BOARD OF ZONING APPEAL

BZA Application Form

BZA Number: 155115

LOCATION OF PROPERTY: 35 Webster Ave., Cambridge, MA

② SOUTH ELEVATION - UNIT 33
1/4" = 1'-0"

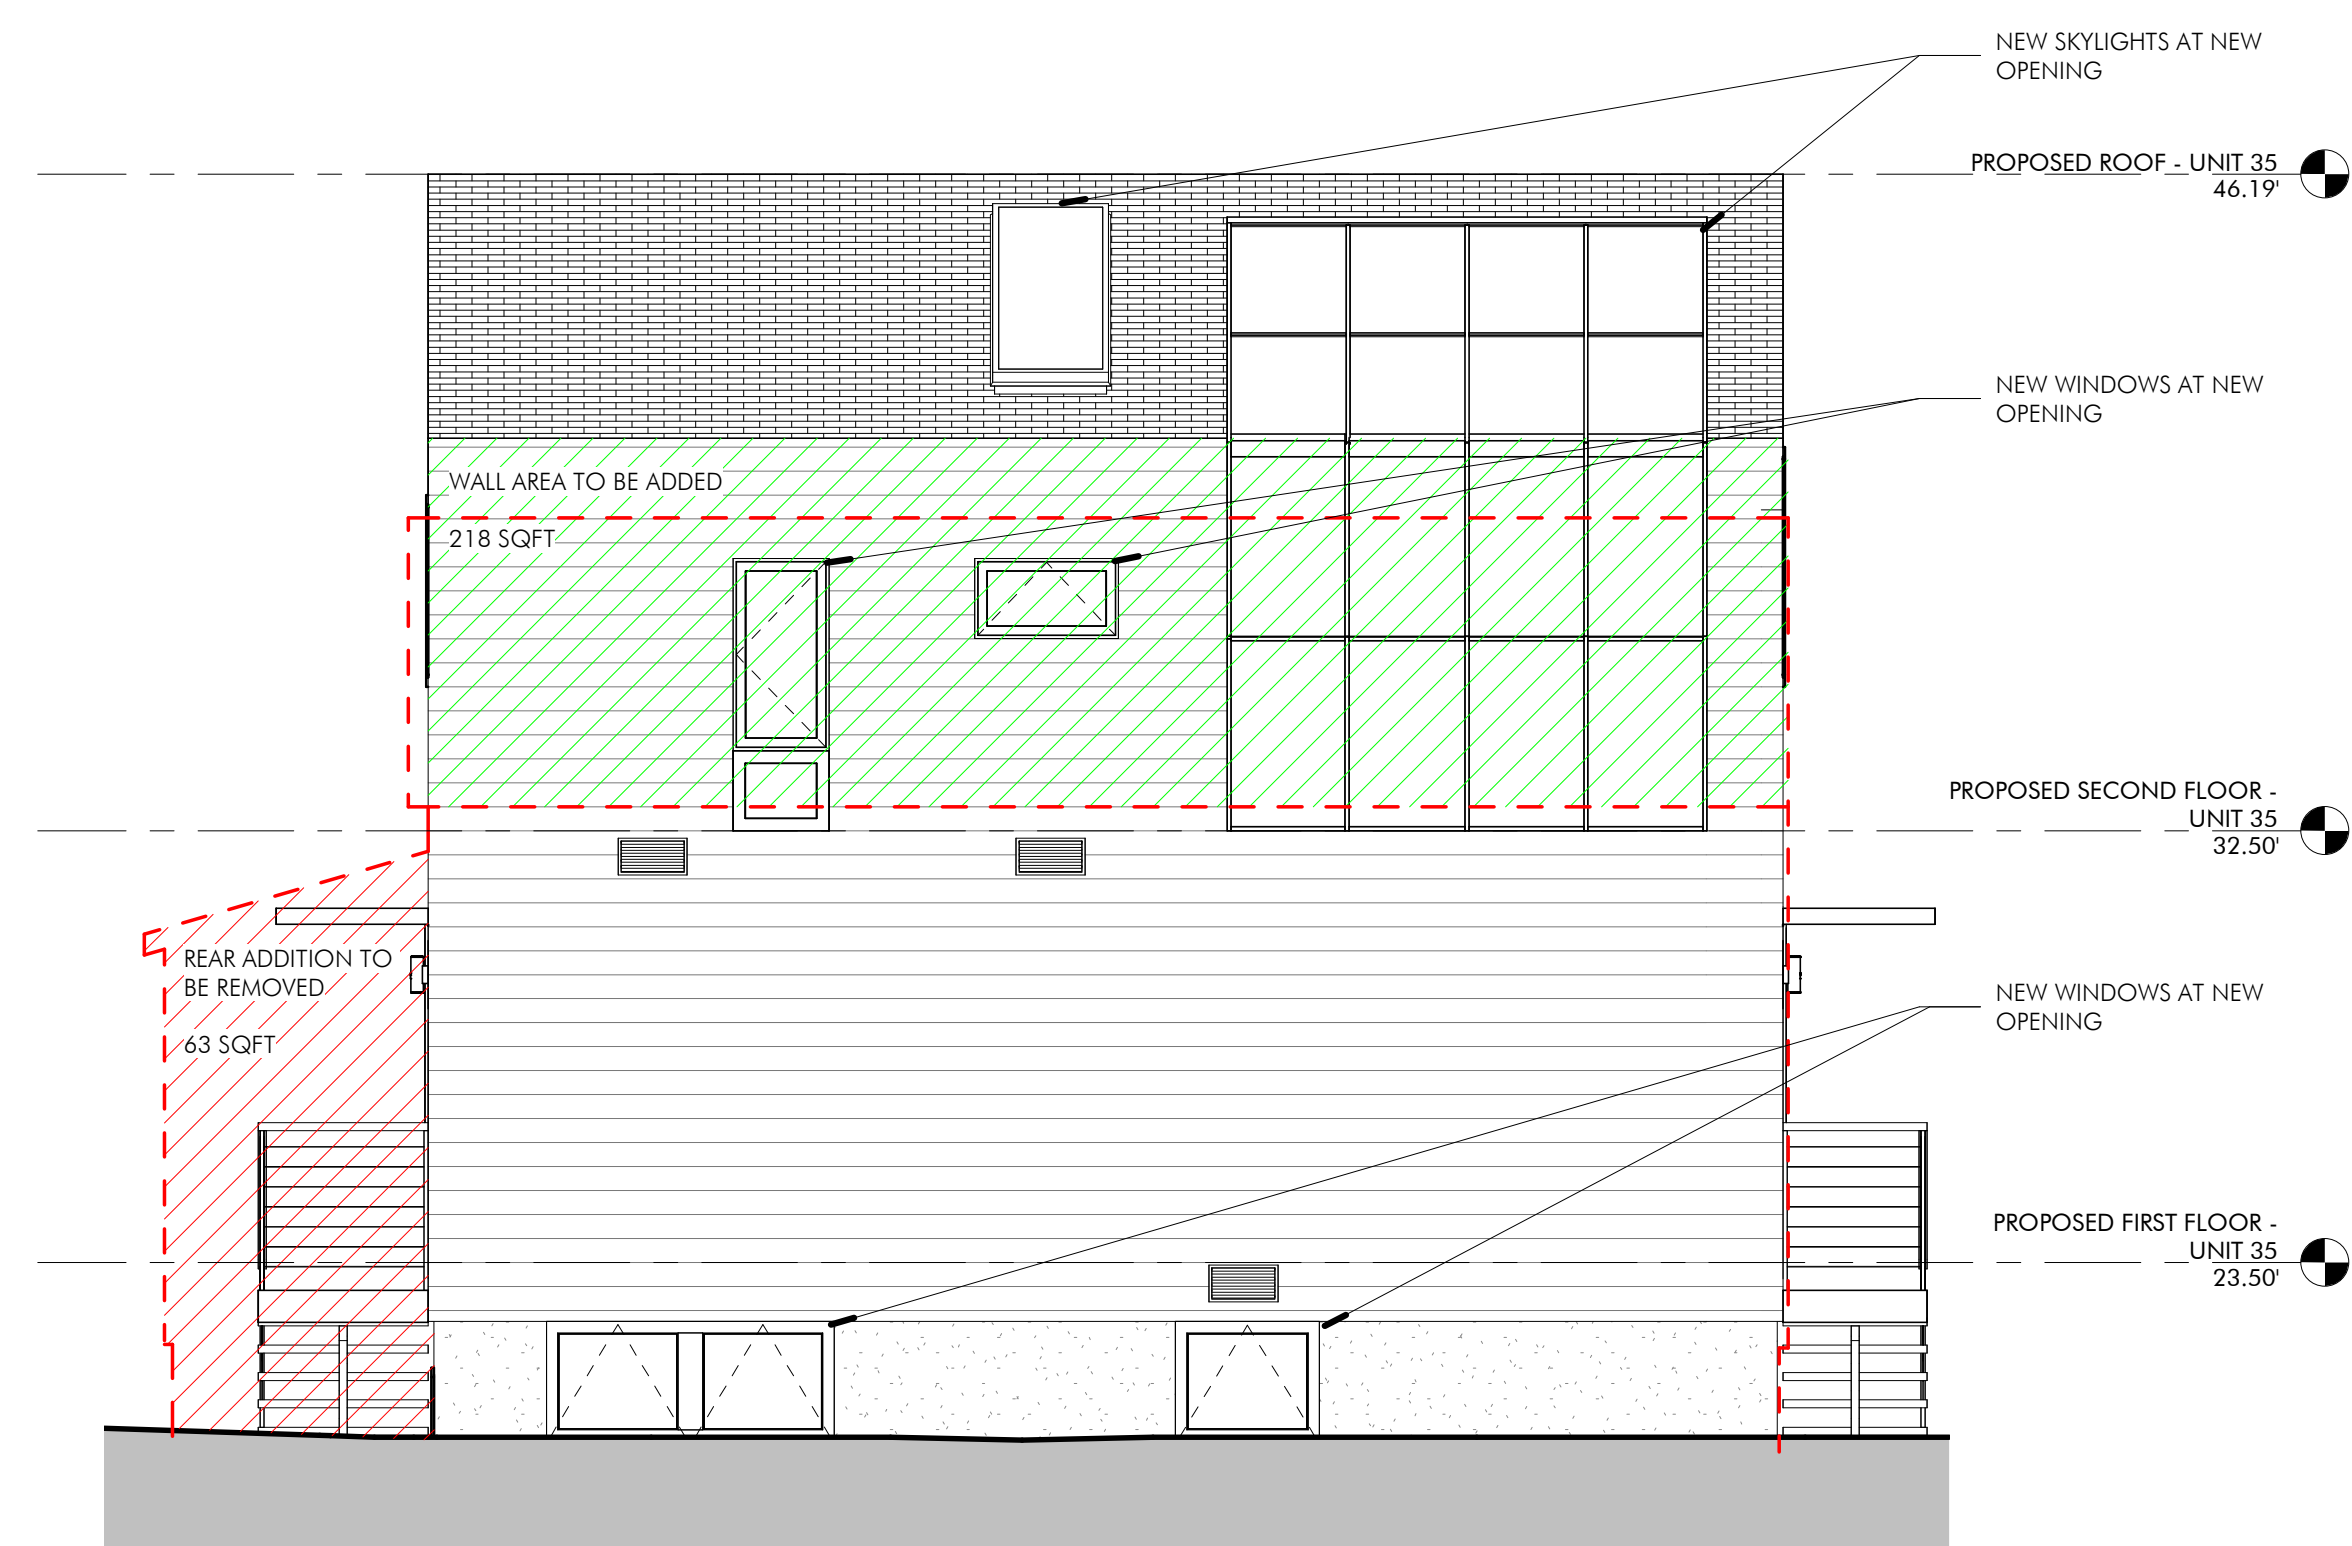
- The proposed SOUTH ELEVATION - UNIT 33 has a 2-story high attachment that acts like a 2-story fence. However, the installation of such an attachment fence poses security dangers to nearby units. In fact, this attachment fence was not present when the developer first presented his plan to us. Therefore, we are opposed to this attachment fence. Such a partially enclosed space is also not clearly defined to be excluded from the GROSS FLOOR AREA.

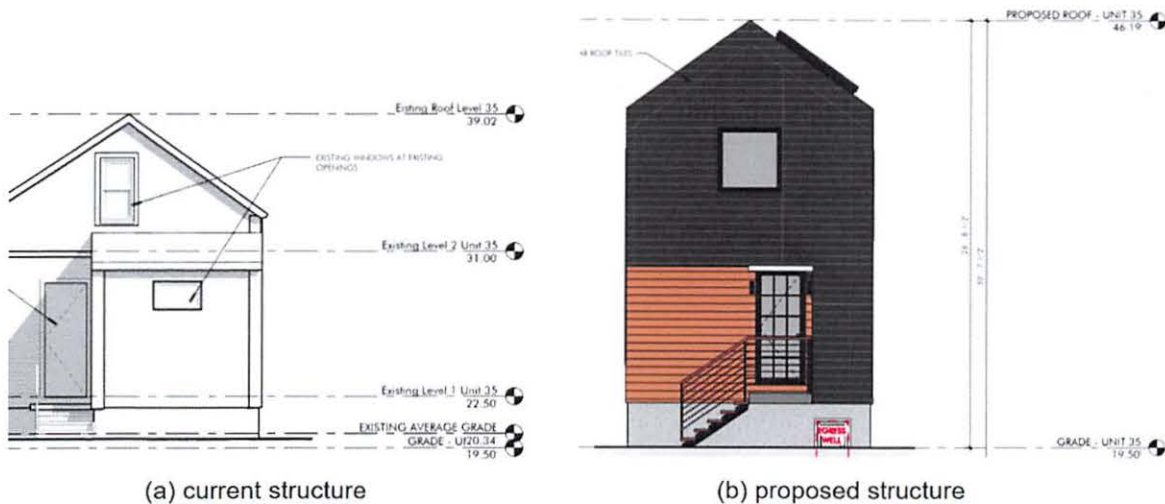
For Requirement 2, the current height of the structure (Roof Level - Grade) is 19.52' (Page 15 of the application as shown below) and the proposed height is 26.69' (Page 19 of the application as shown below). With this 36.7% increase in building height, the volume of the current nonconforming structure will almost definitely be increased by more than 25%.

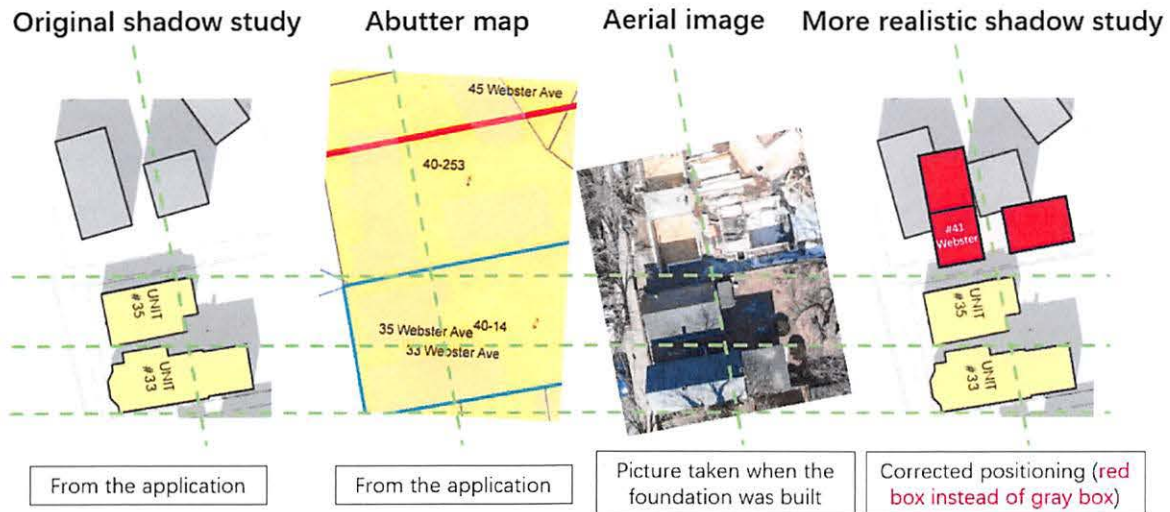
The current shadow study (Page 27, 28 of the application) is inaccurate and greatly **underestimated** the shadow impact. We use aerial imagery to demonstrate the inaccuracy and to correct the building location of 41 Webster (red box as shown in the following figure). From the corrected results, we can see **41 Webster is at least twice**

as close as it was shown in the applicant's shadow study and thus the negative impact of the extra height of the proposed structure is substantially greater.

Parallel auxiliary lines are added to the above figure to demonstrate that all the above images are aligned, scaled, and rotated correctly.

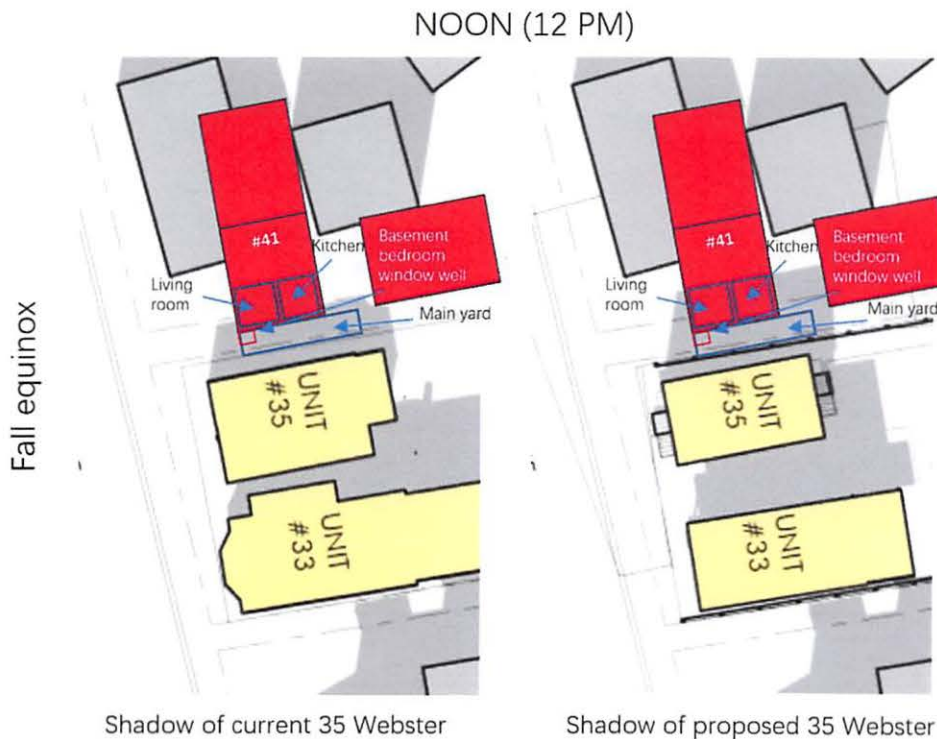
To visualize the impact, we use the noon of the fall equinox day as an example (shown below) where we can see how 41 Webster's living room, kitchen, second floor bedroom's sunlight are being blocked (in addition to the basement bedroom and yard) by the proposed extra height of 35 Webster.

35 Webster's second-floor floor plan (before and after)

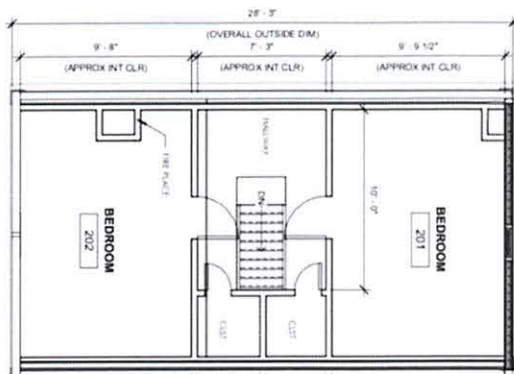
From Page 18 of the application (also shown below), after increasing the non-conforming structure height by 7.17' (nearly the height of one story), the second floor of 35 Webster even reduces to a single bedroom (originally two bedrooms) but with luxurious windows and height. Considering the damage it does to our unit (affecting sunlight for four rooms and yard), this excessive luxury ceiling height is quite unjustified. **This shows the flavor of the application is more for profit than addressing hardships and the negative impact to the neighbors is severely understated, under-researched, even inaccurately presented.**

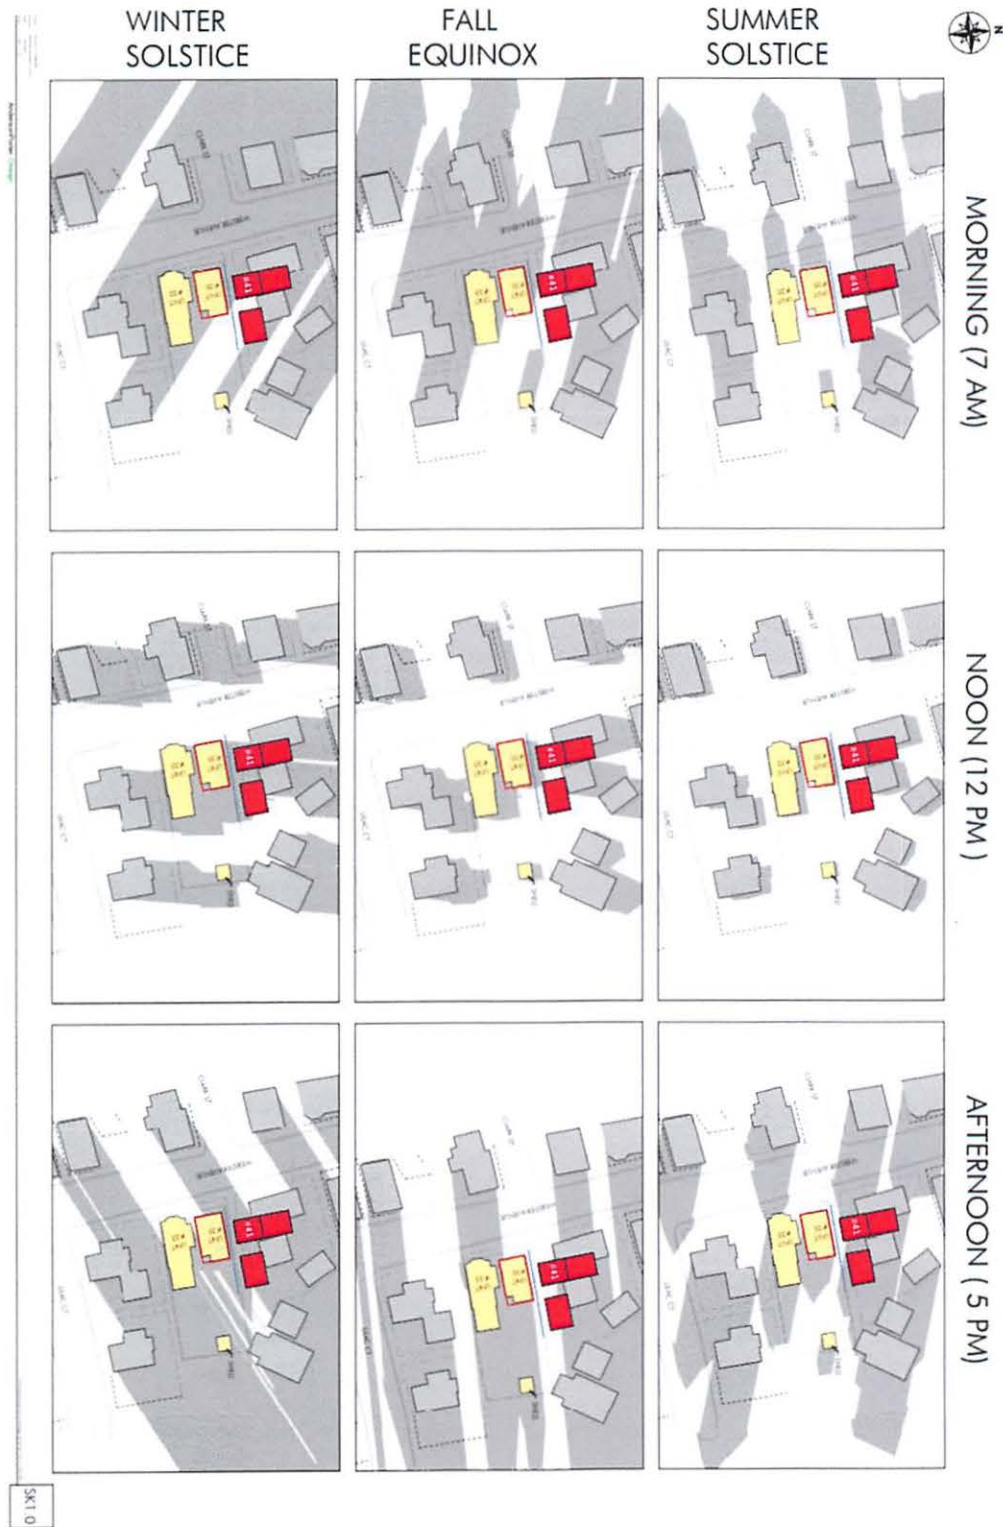
The addition of new openings in non-conforming wall setback also poses privacy concerns as they are directly facing our second floor bedroom windows.

Corrected shadow study of the proposed structure (red boxes indicate correct building locations)

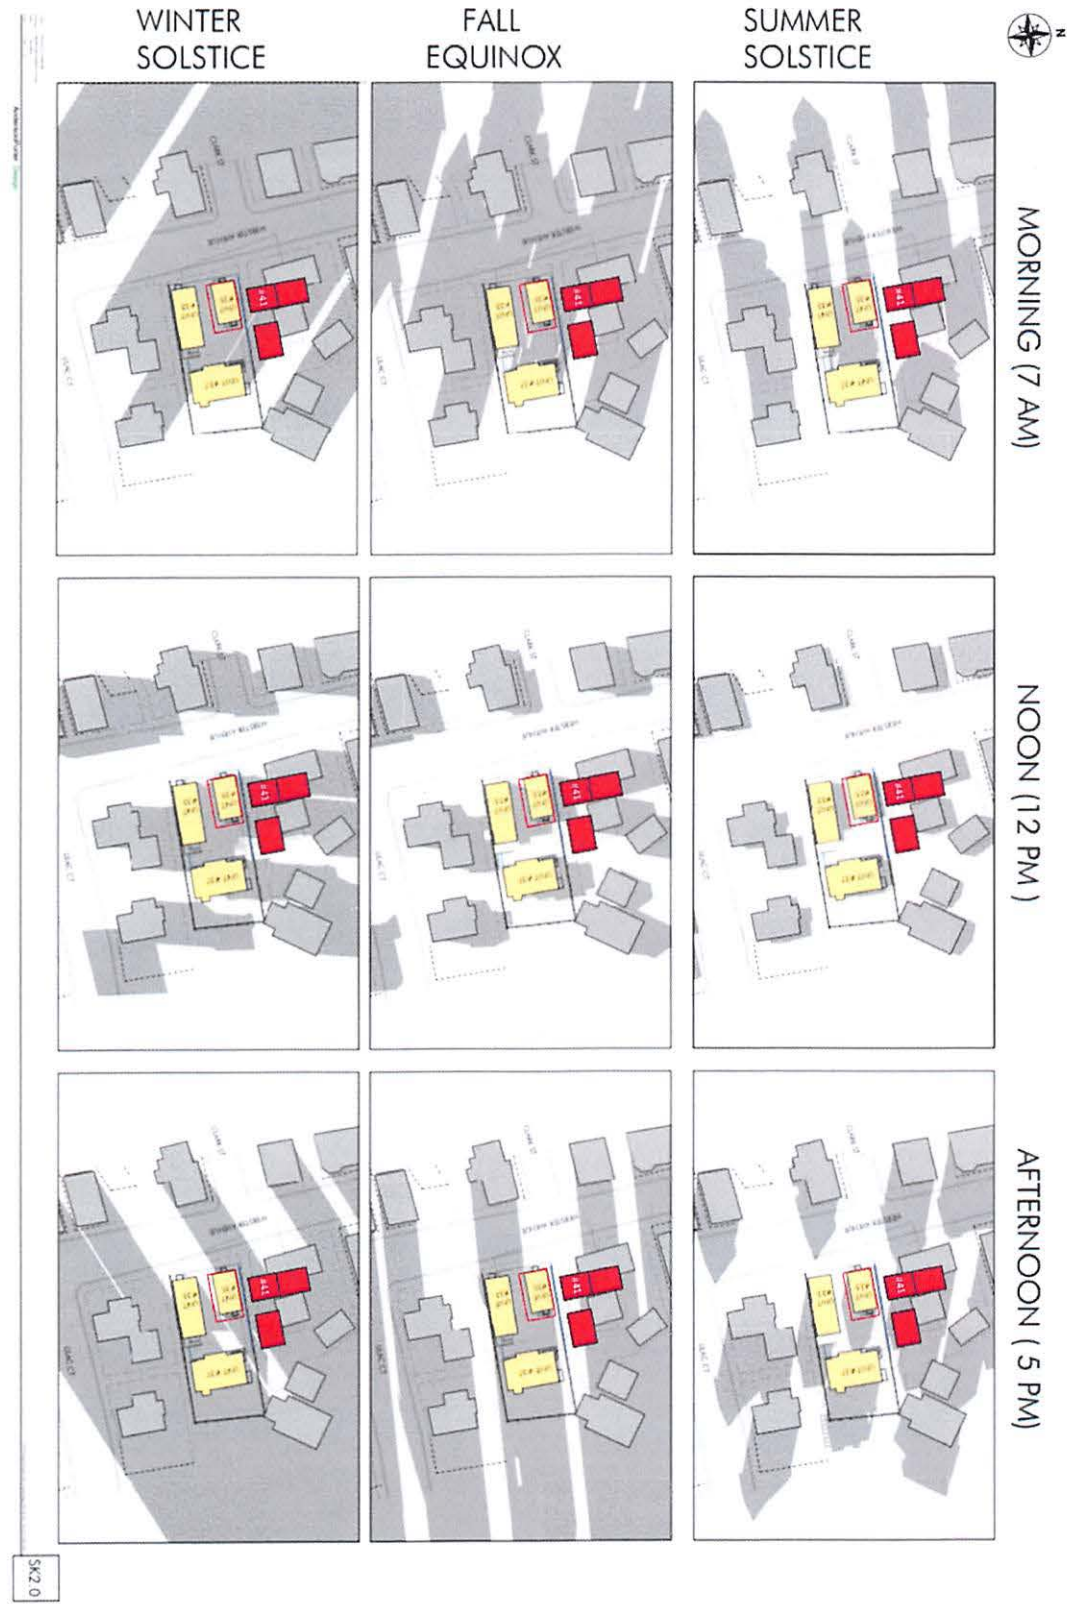
To investigate the real impact, we adopted the applicant's shadow study with the correct location of 41 Webster. The corrected shadow study is provided in the appendix of this letter. We can see the current 35 Webster structure is already negatively affecting sunlight of 41 Webster's yard due to its non-conforming side setback. With the extra 7.17' height in the proposed application, it will not only affect the yard but also affect many rooms of 41 Webster, which we will discuss in detail in the next section.
